February 29, 2024

Re: Vector Development Company Freeman Road Logistics Project: Third-Party Second Review of Critical Areas Report

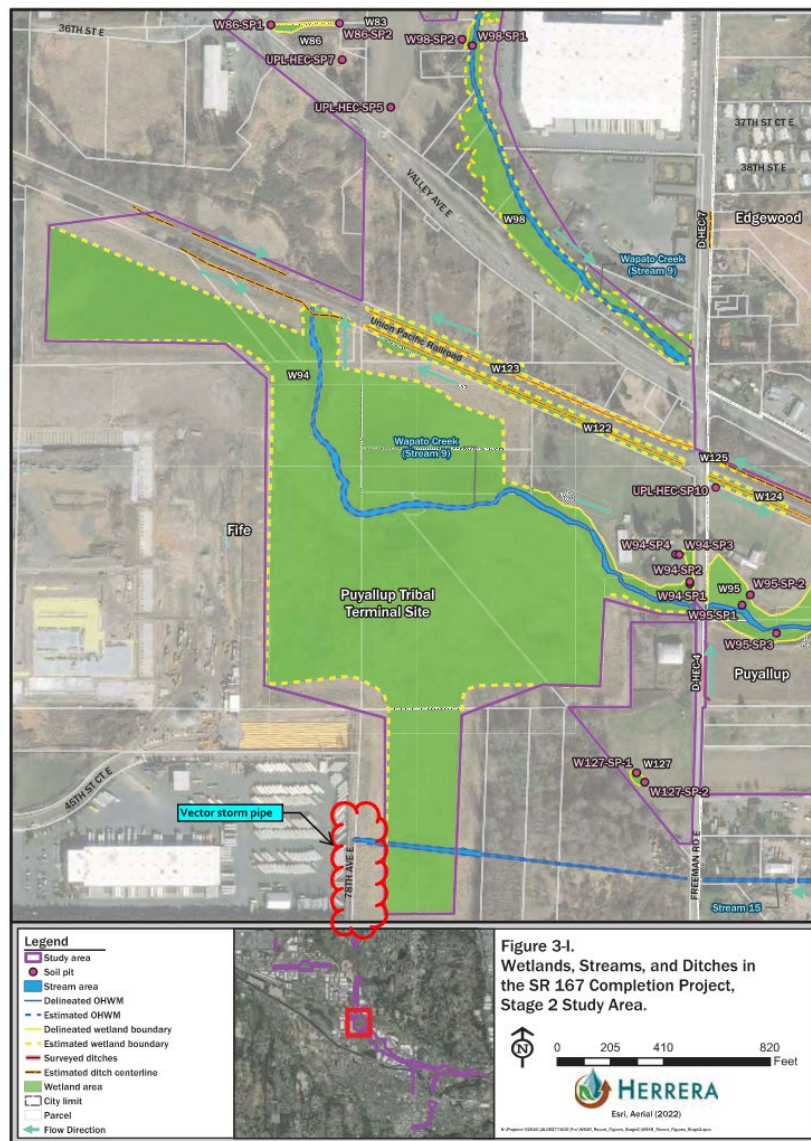
- Stream 15 crosses Freeman Road, continues west, and intersects with the proposed drainage easement (see figure below).

- A wetland has been identified on parcel 0420174707 in association with a Tribal mitigation project (see figure below). The proposed easement appears to be in the buffer. Anchor needs to verify that the easement width (as shown by the applicant's engineering team) is sufficient to be approved by Fife's Public Works Department; they have not approved the easement dimensions yet.
- Impacts to critical areas and buffers must meet Fife Municipal Code.
- Section 3.2 of the 2023 CAR states that there are no streams in the study area. However, Stream 14 and Stream 15 are in the study area and are shown on Figure 4 as being in the study area. Please correct the text.
